**Comments and amendment proposals to
ECE/TRANS/WP.29/GRVA/2020/21 (in purple)**

OICA supports the principles of the proposal from CLEPA. The EMB technology is clearly of importance for the development of electric vehicles.

Proposal for Supplement 17 to the 11 series of amendments to UN Regulation No. 13 (Heavy vehicle braking)

Submitted by the expert from the European Association of Automotive Suppliers

- 5.2.1.34. Special additional requirements for service braking systems with electro-mechanical braking system with and an electric control transmission**

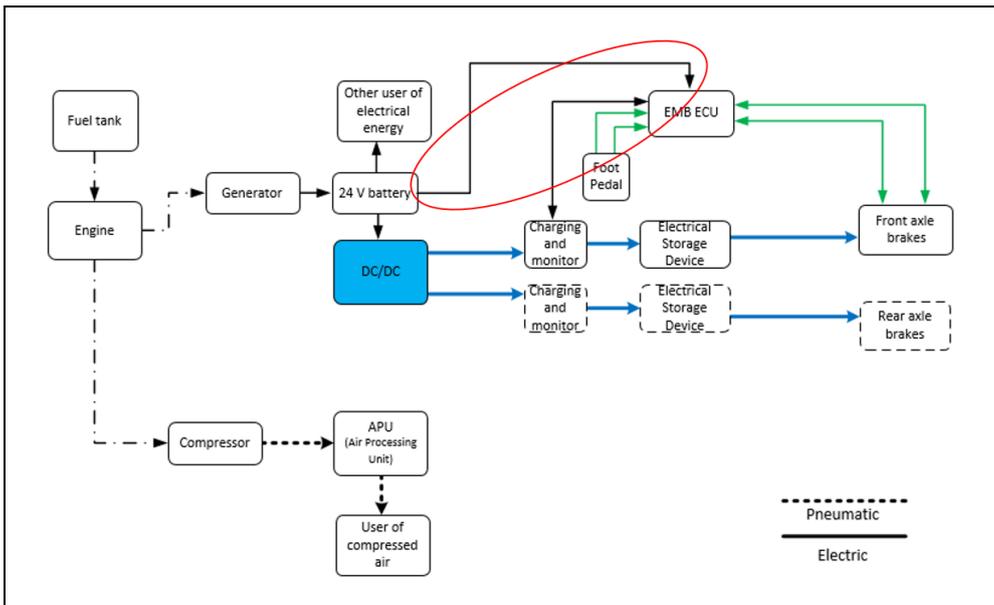
Comment: is it what is meant?

Control transmission	Energy transmission	Relevant paragraph	
		5.2.1.27	5.2.1.34
Air	Air	NA	NA
Electrical (EBS)	Air	x	NA
Electrical (EMB control)	Electrical (EMB)	NA	x
Air	Electrical (EMB)	irrelevant, won't exist

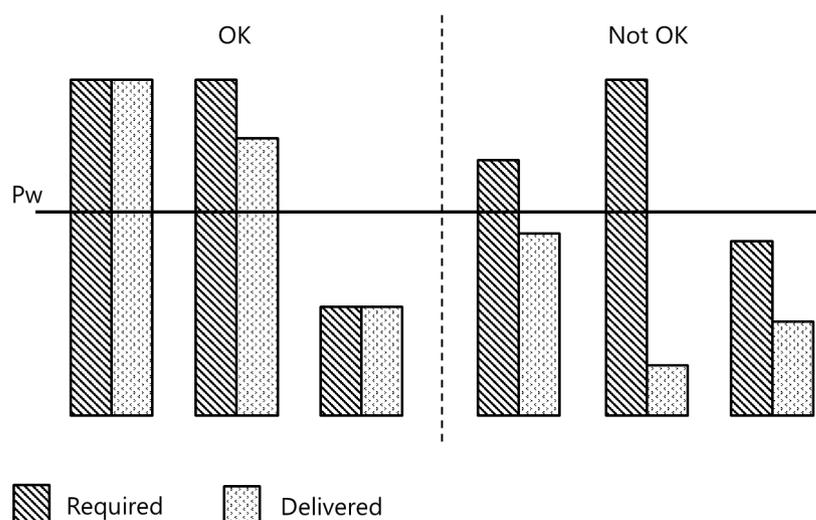
5.2.1.34.8. When the supply of power ~~requested by the electrical energy storage device(s) cannot be met~~ by the electrical supply device ~~and it~~ falls below a value of P_w , declared by the manufacturer, a warning to the driver shall be activated. The yellow warning signal specified in paragraph 5.2.1.29.1.2. may be used.
